MEMORANDUM

SUBJECT: Comments on the Draft Storm Water Source Control Evaluation with Source Control Measurement Performance Monitoring
Lampros Steel, Portland, Oregon
ECSI # 2441
August 28, 2023

FROM: Laura Hanna, RG, Remedial Project Manager 
Superfund and Emergency Management Division, EPA

Figure 1. River Mile 3.5 East Project Area and associated Outfalls

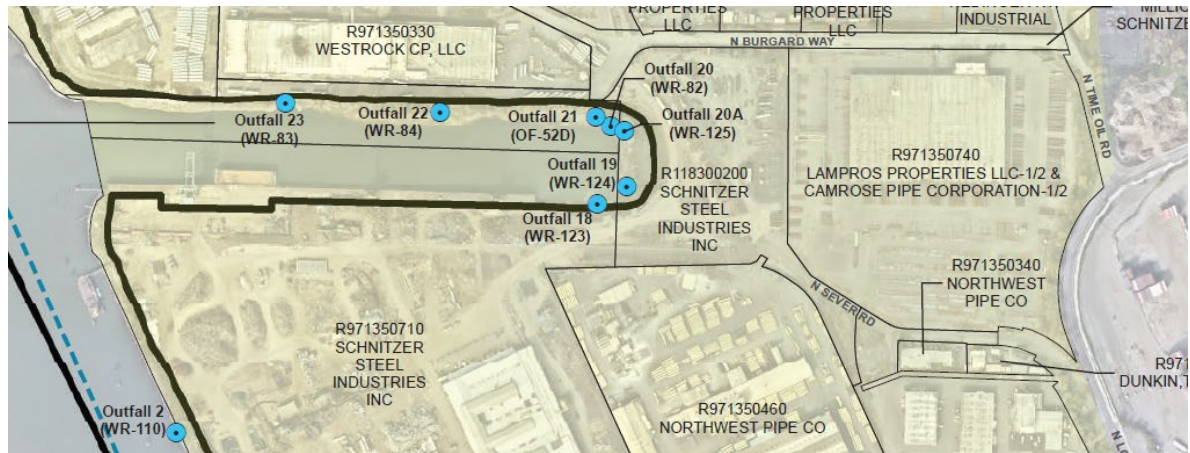
5. Verify the location of the outfall (APC216) shown in Figure 4 Storm Water Conveyance Map (Distal) is correct and update the figure and text, as needed. EPA believes Figure 4 is mislabeled and incorrectly shows the location of APC216, which is also known as Outfall 18/WR-123. EPA believes Figure 4 actually shows the location of Outfall 19/WR-124. Below is an excerpt of

Figure 1.2 Project Area from River Mile 3.5 East Remedial Design Pre-Design Investigation Work Plan (Floyd Snider 2022) for comparison.
